DSA CODE AMENDMENT DEVELOPMENT

Tracking	
Date Received:	-
DSA Tracking Number:	N/A
Date Reviewed:	6/24/2019
Status:	Under consideration

Applicable Code
Applicable Code Section(s): CBC Ch. 1, Scope and Administration
Topic: Public housing

Figure 11B-604.3.2 (Exception)
Overlap of Water Closet Clearance in Residential Dwelling Units

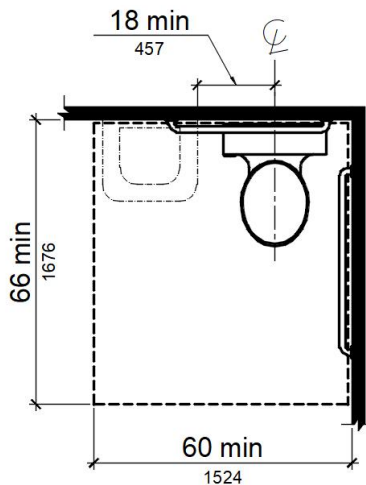
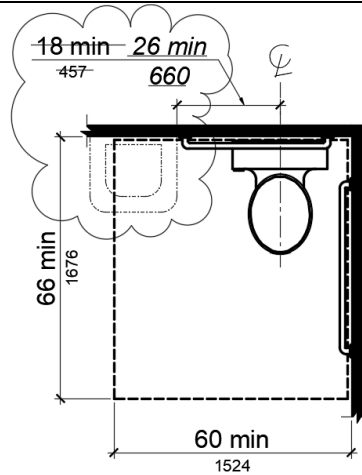
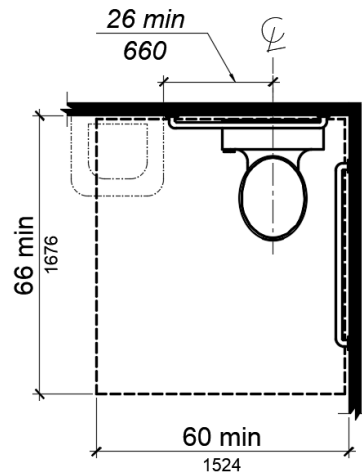
DSA is proposing to amend this figure for the location of a lavatory within the water closet clearance in response to a discussion with the United States Access Board and comments from code users. DSA posed a question to the Access Board related to the figure and whether or not this indicates a compliant installation for the clearance required at the grab bar. The representative from the Access Board stated that the Access Board recognizes that the figure is incorrect and if and when amendments are proposed to the 2010 ADAS one of the items they would propose to correct is this figure. In addition,

Exception: In residential dwelling units, a lavatory complying with *Section 11B-606* shall be permitted on the rear wall ~~18 inches (457 mm)~~ 26 inches (660 mm) minimum from the water closet centerline where the clearance at the water closet is 66 inches (1676 mm) minimum measured perpendicular from the rear wall.

**FIGURE 11B-604.8.1.2
MANEUVERING SPACE WITH SIDE-OPENING DOOR**

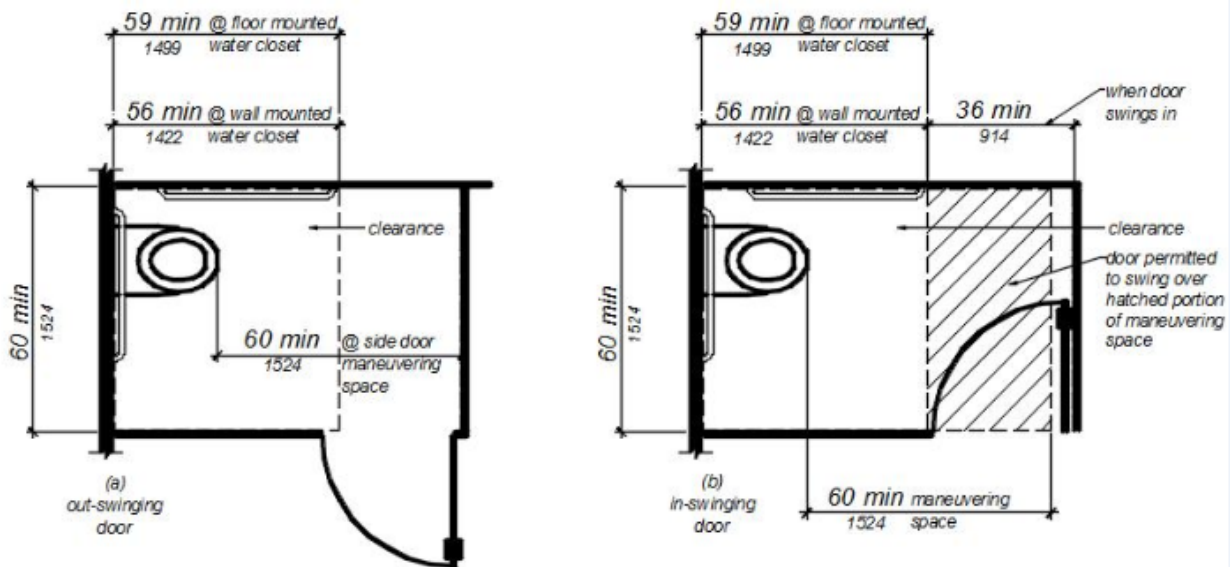
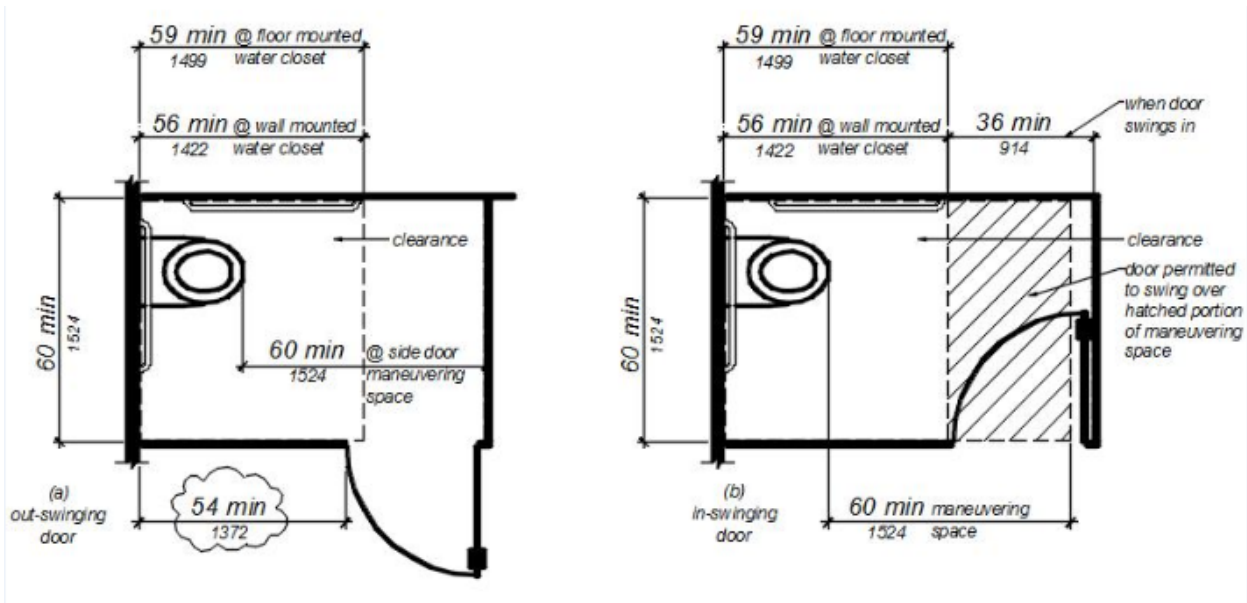
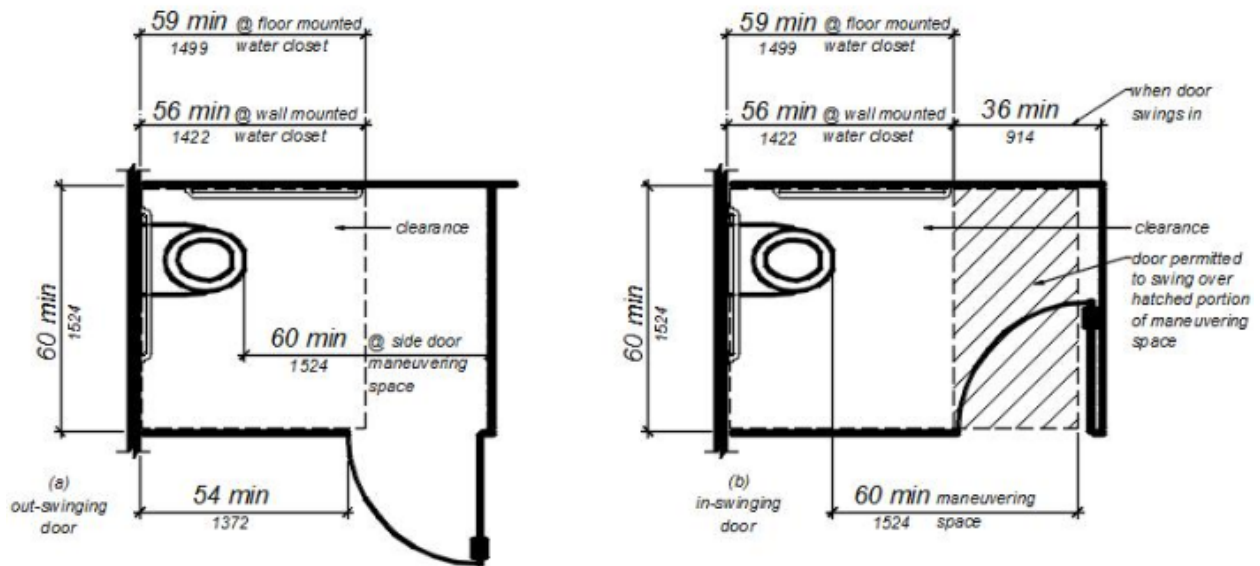
DSA-AC is proposing to amend Section 11B-604.8.1.2 and Figure 11B-604.8.1.2 to revise the required location for out-swinging toilet compartment doors in the side wall or partition of an accessible toilet compartment. The current provisions require the door to be 4 inches maximum from the front partition. This proposal allows the toilet compartment door to be located in a variety of locations in the side wall or partition while maintaining equal or greater accessibility than the current CBC Chapter 11B requirements and the 2010 ADA Standards for Accessible design.

11B-604.8.1.2 Doors. Toilet compartment doors... Doors shall be located in the front partition or in the side wall or partition farthest from the water closet. Where located in the front partition, the door opening shall be 4 inches (102 mm) maximum from the side wall or partition farthest from the water closet. Where located in the side wall or partition, ~~the door opening shall be 4 inches (102 mm) maximum from the front partition~~ *the door opening shall be farthest from the water closet and shall be 54 inches (1372 mm) minimum from the rear wall.* ...

Figure 604.8.2
Ambulatory Accessible Toilet Compartment

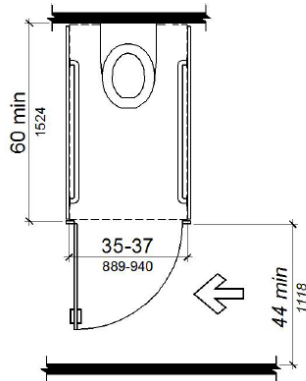
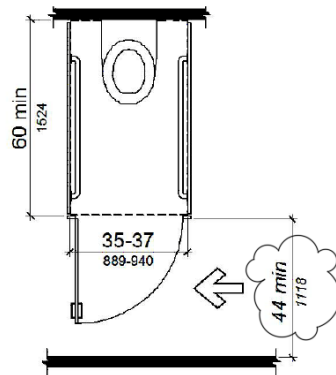
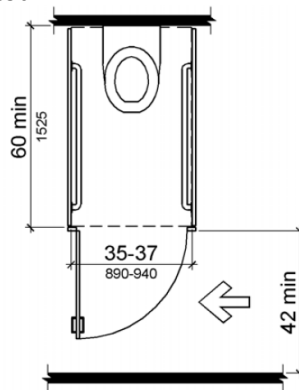
DSA is proposing to amend this section in order to correct a drafting error made during the 2012 Rulemaking cycle when Chapter 11B was rewritten using the 2010 ADA Standards for Accessible Design as model language with California amendments.

11B-604.8.2.2 Doors. Toilet compartment doors, including door hardware, shall comply with *Section 11B-404*, except that if the approach is to the latch side of the compartment door, clearance between the door side of the compartment and any obstruction shall be 42 inches (1067 mm) minimum. The door shall be self-closing. A door pull complying with *Section 11B-404.2.7* shall be placed on both sides of the door near the latch. Toilet compartment doors shall not swing into the minimum required compartment area.

Figure 11B-608.5.2
Standard Roll-In Type Shower Compartment Control Location

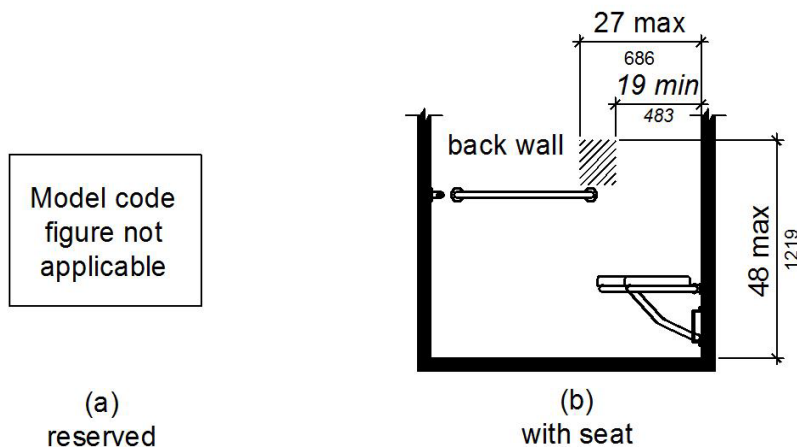
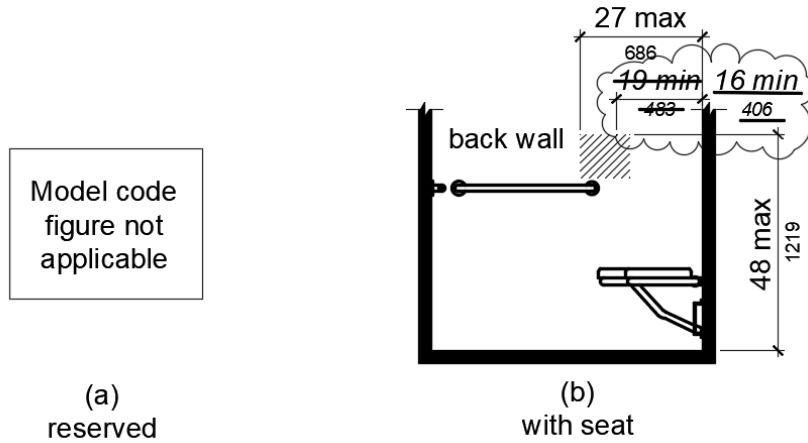
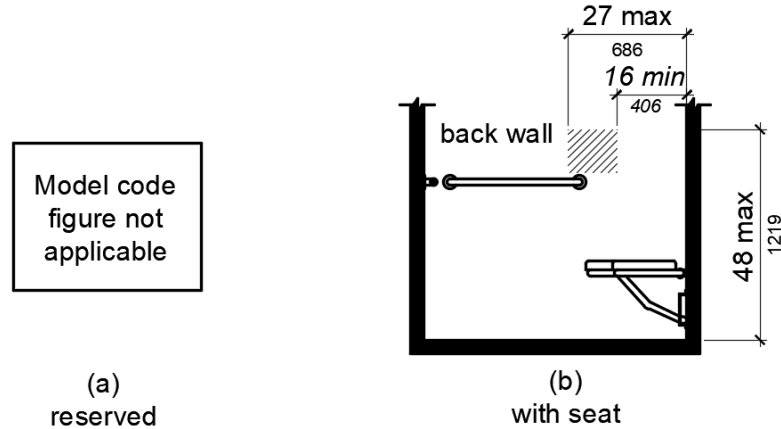
DSA is proposing to amend these sections in response to comments from code users to address the following issues.

- DSA does not use the International Building Code or ANSI A117.1 Accessibility Standard as model code, however the range proposed in this code change is consistent with ANSI A117.1 and is more restrictive than the 2010 ADAS.

11B-608.5.2 Standard roll-in type shower compartments. In standard roll-in type shower compartments, the controls, faucets, and the shower spray unit shall be located on the back wall of the compartment adjacent to the seat wall 16 inches (406 mm) minimum and 27 inches (686 mm) maximum from the seat wall; and shall be located above the grab bar, but no higher than 48 inches (1219 mm) above the shower floor.
